UNITED STATES PATENT AND TRADEMARK OFFICE

APPLICATION NO.	FILING DATE	FIRST NAMED INVENTOR	ATTORNEY DOCKET NO.	CONFIRMATION NO.
10/699,158	10/30/2003	Ralf Zuber	13574 US	1631
23719	7590	07/28/2006	EXAMINER	
KALOW & SPRINGUT LLP 488 MADISON AVENUE 19TH FLOOR NEW YORK, NY 10022			WILLS, MONIQUE M	
			ART UNIT	PAPER NUMBER
			1745

Office Action Summary	Application No. 10/699,158	Applicant(s) ZUBER ET AL.	
	Examiner Monique M. Wills	Art Unit 1745

DETAILED ACTION

F I G. 3

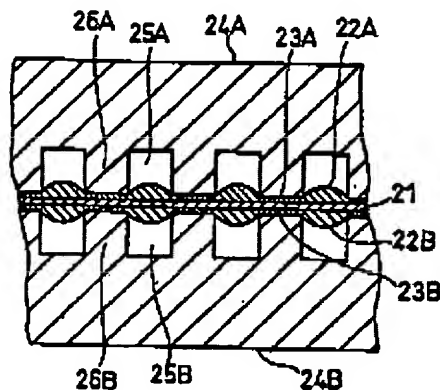
With respect to claim 1, Shibata teaches a membrane electrode unit for electrochemical equipment, containing: an ionically conductive membrane (par. 51) with a front and back side, a first catalyst layer (2A) and a first gas distributor substrate (3A) on the front side and a second catalyst layer (2B) and a second gas distributor substrate (3B) on the back side, in which the first gas distributor substrate has lesser surface dimensions than the ionically conductive membrane and the second gas distributor substrate has essentially the same surface dimensions as the ionically conductive membrane. See Fig. 3.

In re claim 2, the catalyst layer on the front side and the catalyst layer on the back side of the ionically conductive membrane have different surface dimensions. See Figure 3.
